MFN 07-346

**Subject: Response to Portion of NRC Request for Additional Information
Letter No. 90 - Emergency Core Cooling Systems - RAI Numbers
6.3-76 and 6.3-77**

RAI Numbers 6.3-76 and 6.3-77

**Figure 6.3-76-1. Comparison of Downcomer (DC) Collapsed Level
Nominal vs. Bounding Cases
(Main Steam Line Break, 1 GDSCS Valve Failure)**

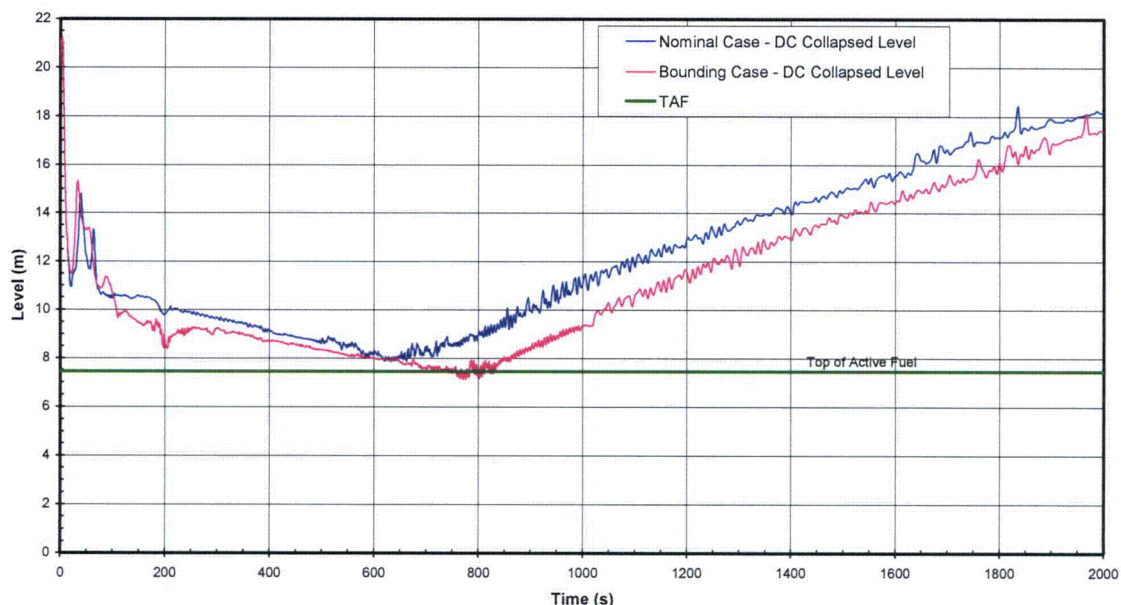
In the DCD Revision 2, Table 6.3-5 the minimum chimney static head for the steam line break inside containment for the cases run with bounding values are higher than those run using the nominal values. Please explain.

Figure 6.3-76-1 compares the downcomer collapsed levels for the nominal and bounding cases. Throughout the transient, the downcomer collapsed level for the bounding case is lower than that for the nominal case. The level rebounds shortly after the initiation of GDCS flow. The downcomer collapsed level rises back to 10 m elevation at about 900 seconds for the nominal case, and at about 1050 seconds for the bounding case. After this time, the downcomer as well as the lower plenum regions are filled with subcooled water from the GDCS pools. The downcomer collapsed levels continue to rise for the remainder of the transient.
